# PARTS & SERVICE NEWS

REF NO.	AT00195
DATE	Sep. 26, 2000

**SUBJECT:** INTRODUCTION OF IMPROVED DISPLAY OF PLM MEMORY ON DUMP TRUCK

**PURPOSE:** To introduce improved payload meters (PLM) to eliminate indication errors of the operation data being stored in the card-type payload meter being installed on HD785-3, HD785-5, HD985-3, HD985-5, HD465-5, HD605-5, HD325-6, HD405-6 and HD1200-1 dump trucks

Fig. 1

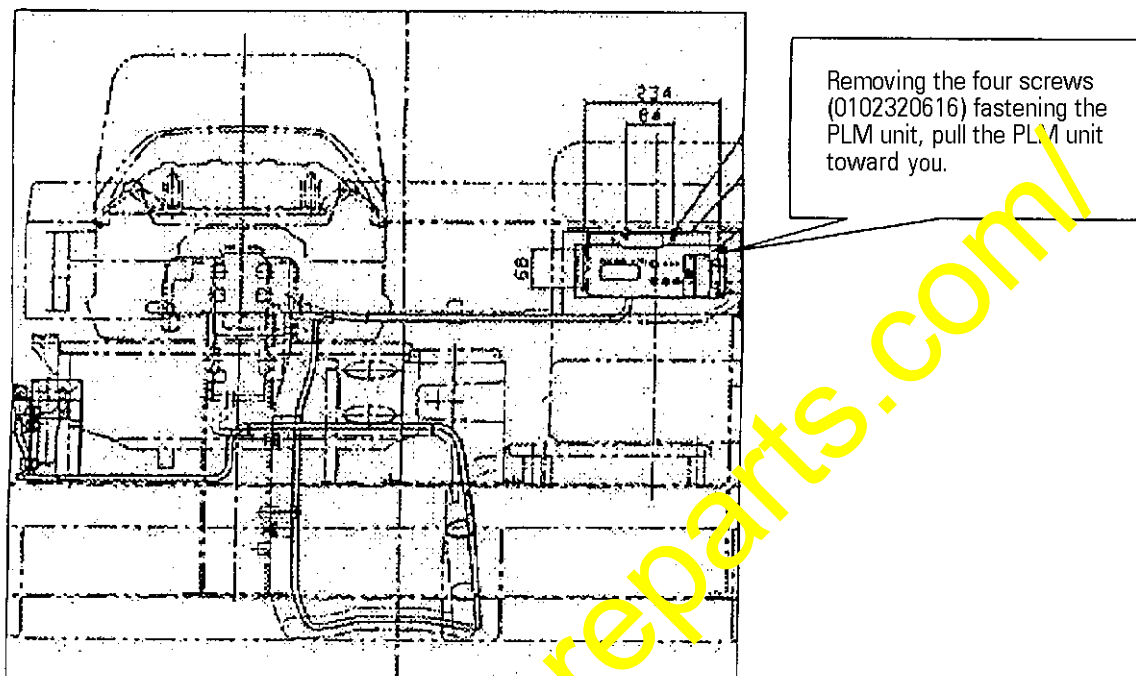
- (1) Park the vehicle on a level place, apply the parking brake, turn off the starting key and insert chocks behind the wheels.
- (2) Remove the PLM unit located in front of the assistant's seat. Refer to Fig. 1 and Fig. 2.

- (3) Replacing the PLM unit with the improved unit (561-86-67405 in cases of the HD785-3, HD785-5, HD985-3, HD985-5, HD465-5, HD605-5, HD325-6 and HD405-6 and 581-86-55801 in cases of the HD1200-1), install the new PLM unit to the original position.
- (4) Execute settings for the PLM referring to Chapter 11 "When the error code "F. CAL" appears or necessary adjustment to make after replacing the controller" in the Instruction Manual for the PLM.
